SUNDRY NOTICES AND REPORTS ON WELLS

7. If Unit or CA/Agreement, Name and/or No.
Myers Langlie Mattix Unit

8. Well Name and No.
#192

OXY USA WTP LP
Myers Langlie Mattix Unit #192
API No. 30-025-11090

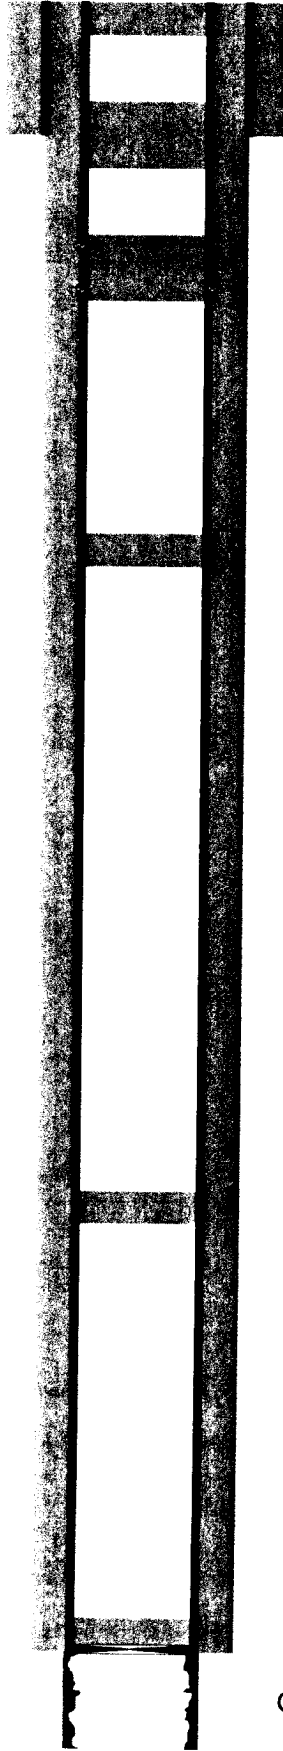
Step 1 Cement on top of CIBP to be 50' if dumped or 35' if bailed.

Step 2 Base of Salt plug 2165'-2265'. Tag plug.

Step 3 100'plug (minimum 25 sx) for Top of Salt (1540'-1640' salt and anhydrite zone), may want to extend Base of Salt plug to cover entire salt formation. Tag plug.

Step 4 OK

Step 5 OK

Step 6 OK
